*Nomad*

SERVICE BULLETIN

SUBJECT: IMPROVED AIR FLOW THROUGH OIL COOLER (MODIFICATION N359)

Rework of Rear Duct Assembly
Figure 1

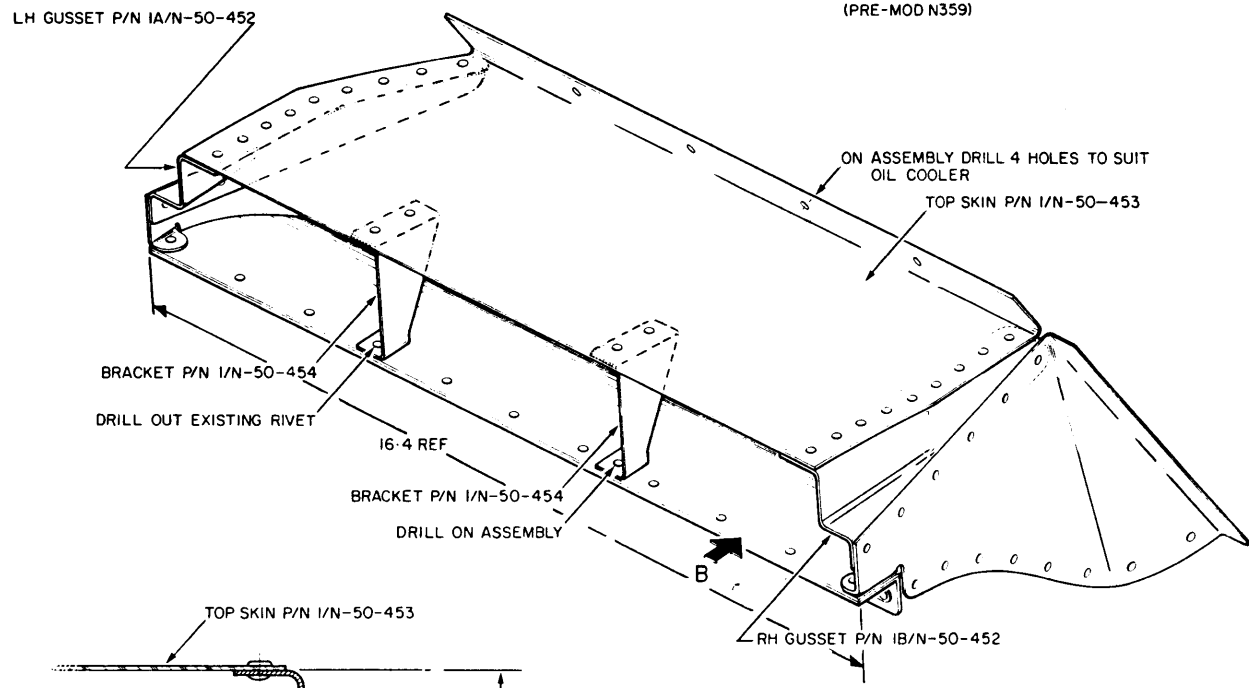
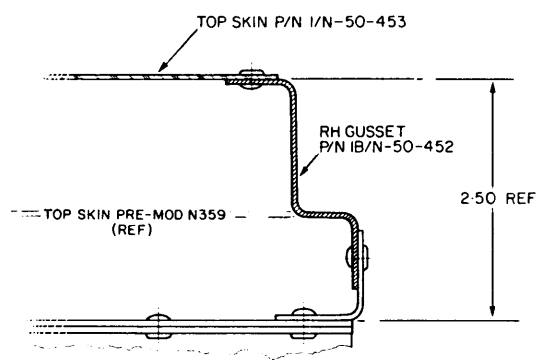
C. Rework the rear duct assembly (P/N 1/N-50-50) (Ref Figure 1).

(1) Drill out the rivet securing the bracket P/N 1E/N-50-50 to the rear duct tray P/N 1/N-50-52.

- (2) Cut away the top section of the rear duct assembly including the angle P/N 1B/N-50-50 and the bracket P/N 1E/N-50-50.
 - (3) Clamp left hand and right hand gussets, P/N 1A/N-50-452 and P/N 1B/N-50-452 in position. Drill and rivet gussets to the sides of the rear duct assembly using rivets P/N MS20470AD4-4. Ensure that the rivet heads are on the inside of the assembly.

- (4) Clamp the new top skin P/N 1/N-50-453 in position. Drill and rivet top skin to the left hand and right hand gussets using rivets P/N MS 20470AD4-4. Ensure that the rivet heads are on the inside of the assembly

- (5) Clamp brackets P/N 1/N-50-454 in position and drill and rivet using rivets P/N MS20470AD4-4. Ensure that the rivet heads are on the inside of the assembly.

- (6) Insert rivet P/N MS 20470AD4-4 in rear duct tray to replace that removed in step (1).
 - (7) Drill four 5 mm diameter holes in upper flange to suit oil cooler.

- (8) Re-identify the rear duct assembly as P/N 2/N-50-50.
- D. Clean off old sealing compound from mating surfaces of oil cooler and reworked rear duct assembly. Pack mating surfaces of oil cooler and reworked rear duct assembly with sealing compound. Fit reworked rear duct assembly to oil cooler and torque tighten new self-locking nuts to between 20 and 25 lb inches.

Rework of Upper Cowl
Figure 2

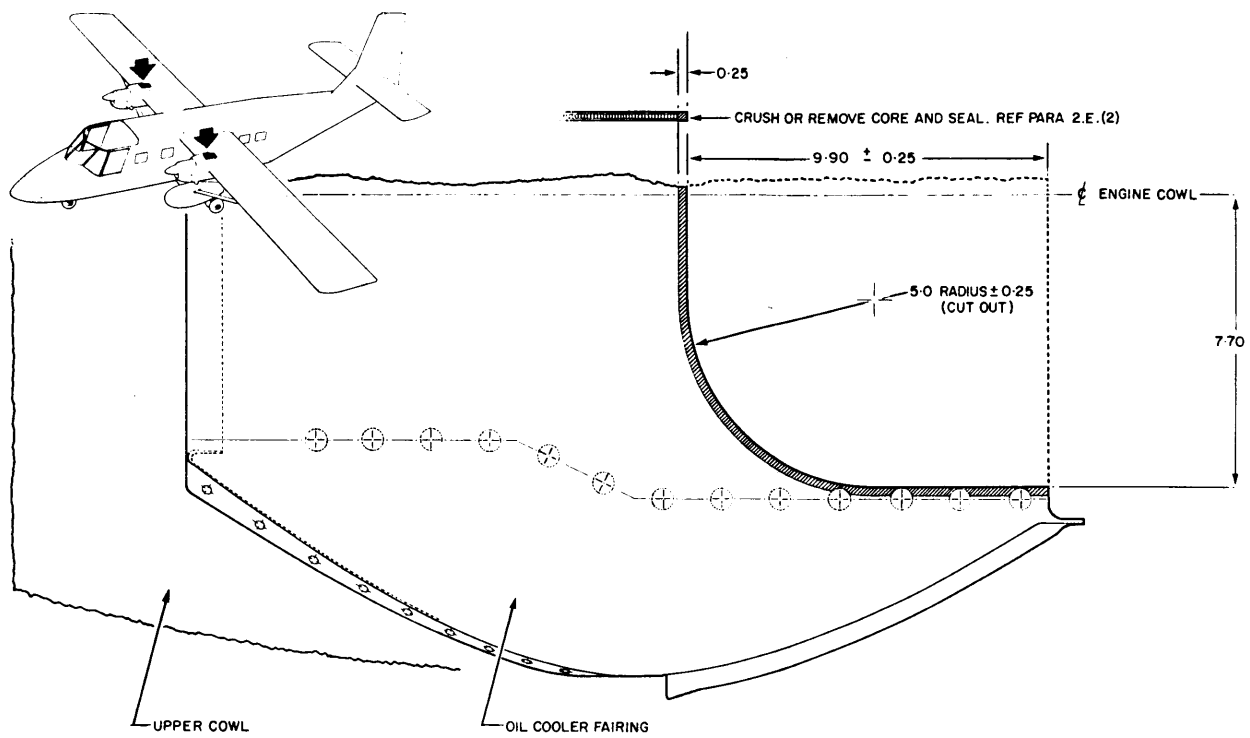
- E. Rework upper cowl (P/N 1/N-50-327 or 2/N-50-327) (Ref Figures 2 and 3).
- (1) Cut out the area of the oil cooler fairing shown in Figure 2.
 - (2) Crush or remove core for a distance of 0.25 inches from the cut edge and seal with a mixture of 100 parts by weight Araldite MY750, 10 parts by weight phenolic microballoons and 10 parts by weight hardener HY950 (Ref Figure 2).

Rear Oil Cooler Fairing-
Position of Rivet Holes
Figure 3

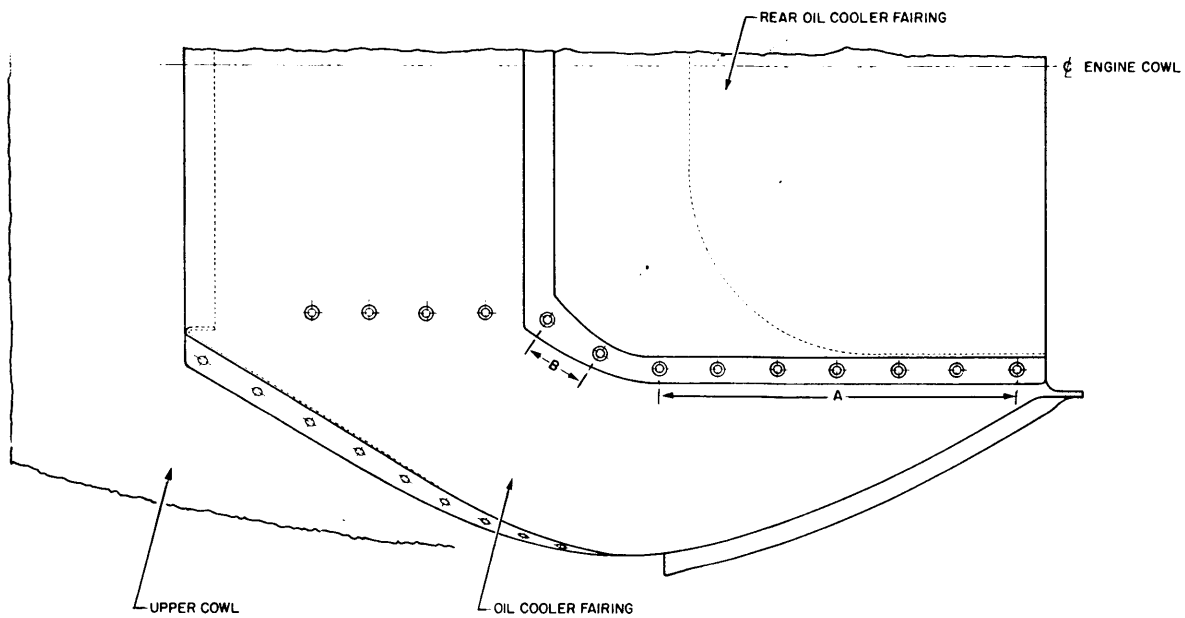
- (3) Drill out rivets marked A and B on Figure 3.
 - (4) Wet assemble rear air cooler fairing P/N 1/N-50-466 to oil cooler fairing using a mixture of an equal volume of Araldite AW106 and hardener HV953U.

- (5) Using a No. 30 drill (0.1285 inches dia, 3.26 mm dia), back drill the new rear air cooler fairing using existing rivet holes in upper cowl stiffeners as a guide.

(6) Rivet new rear air cooler fairing to oil cooler fairing at positions marked A and B on Figure 3 using rivets P/N MS20470AD4-6 and Cherry rivets P/N MS20600AD4-7, respectively.
